Gatwick Airport Northern Runway Project

Change Application Report

Application Document Ref: 9.2

PINS Reference Number: TR020005

Figure 2: Project Change 1 – image showing change to the maximum plan parameters

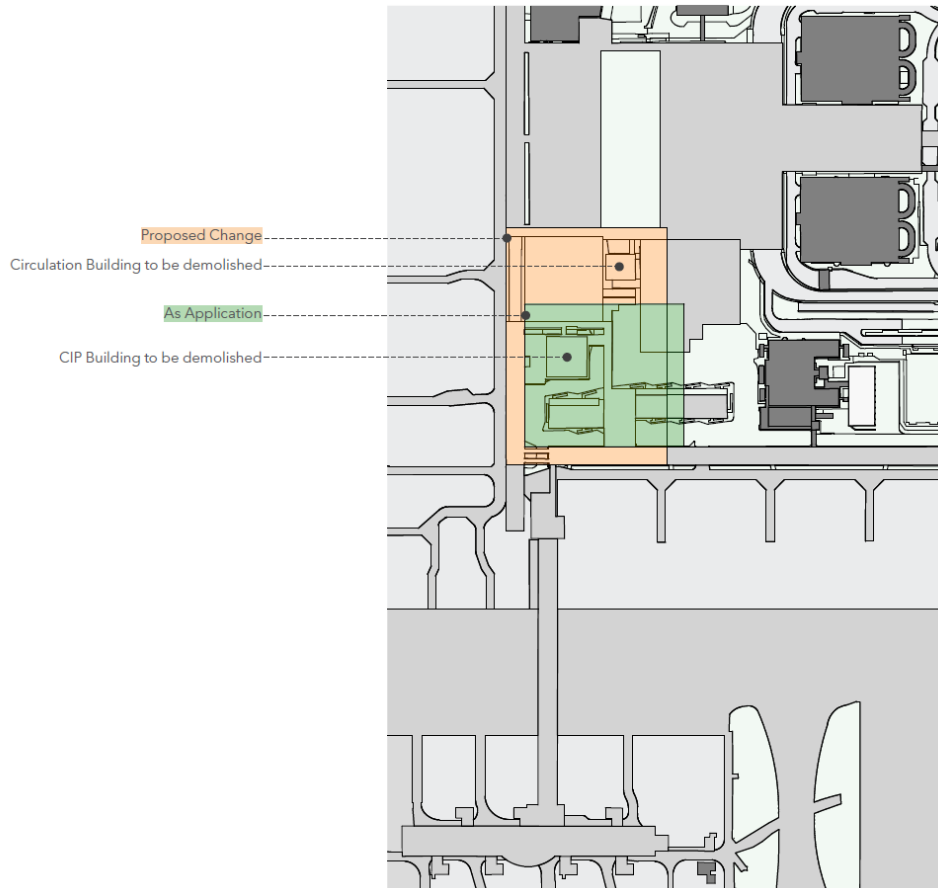
- Increase in the maximum plan parameters from up to 119 x 105 metres (width x length) to up to 120 x 175 metres.
- Increase in the maximum height parameter (above ground level) from 27.5 metres to 30 metres.
- Demolition of the CIP lounge building and the circulation building.

3.1.4 The changes to the maximum parameters are shown in **Figures 2 and 3** below, along with labels identifying the location of the CIP lounge building and circulation building to be demolished.

Figure 5: Project Change 2 – images showing changes to the height parameters

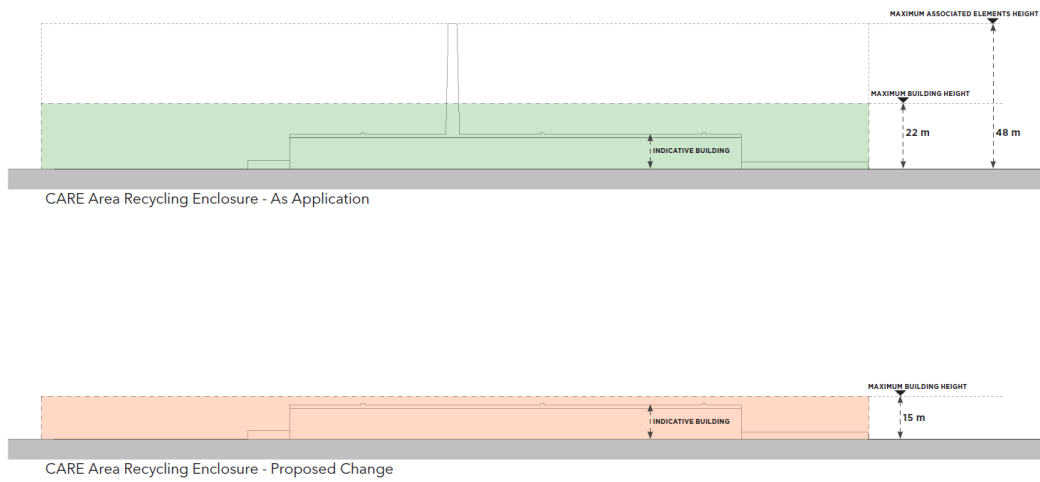
- Decrease in the maximum height parameter (above ground level) of the main building from 22 metres to 15 metres.
- Removal of the proposed biomass boiler flue, which was proposed as being up to 48 metres in height in the Application.
- Removal of the two proposed biomass boilers.

4.1.4 The change to the maximum height parameters is illustrated on **Figure 5** below.

Figure 8: Project Change 3 – aerial sketch of the proposed constructed wetland (reed bed) system

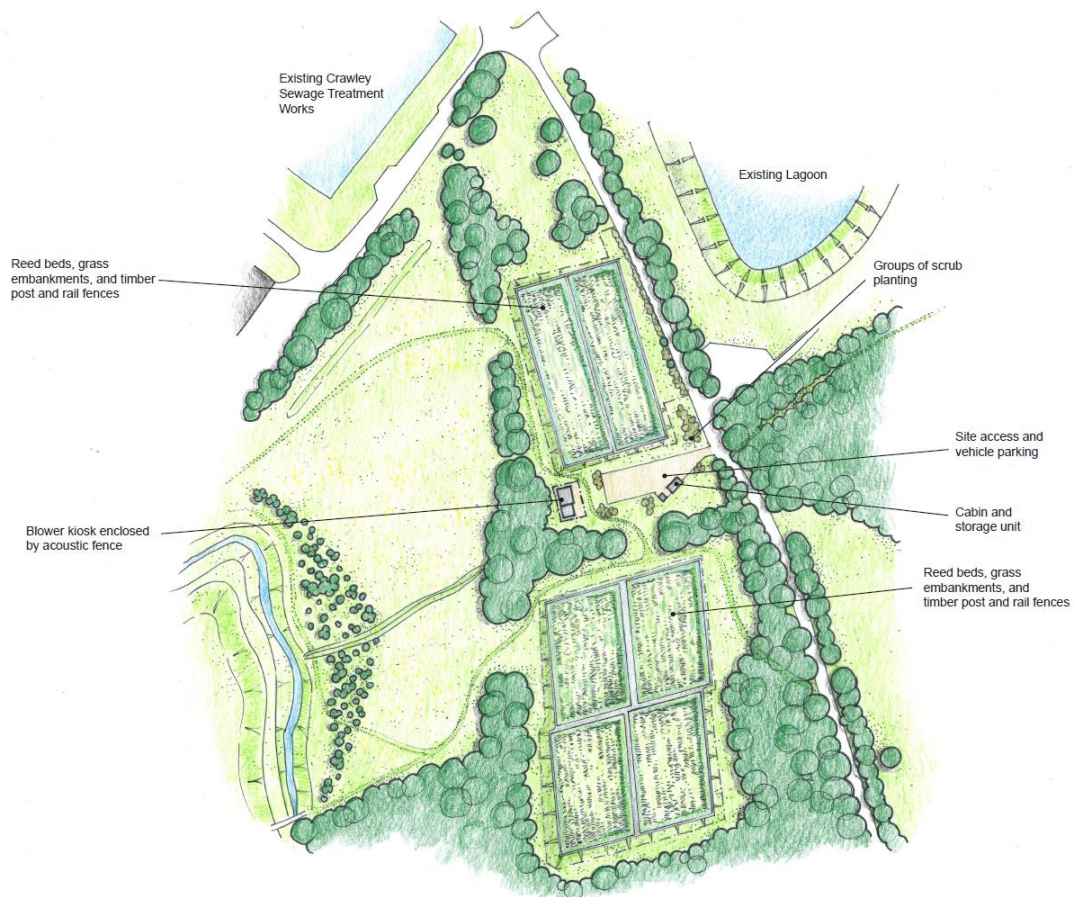
- Change to the water treatment process from a MBBR system to a constructed wetland (reed bed) system entailing different structures and features (described further below).
- Increase in the footprint for the proposed water treatment works to accommodate the constructed wetland (reed bed) system from up to

5.1.3 **Figures 8 and 9** below illustrate the proposed constructed wetland (reed bed) system.
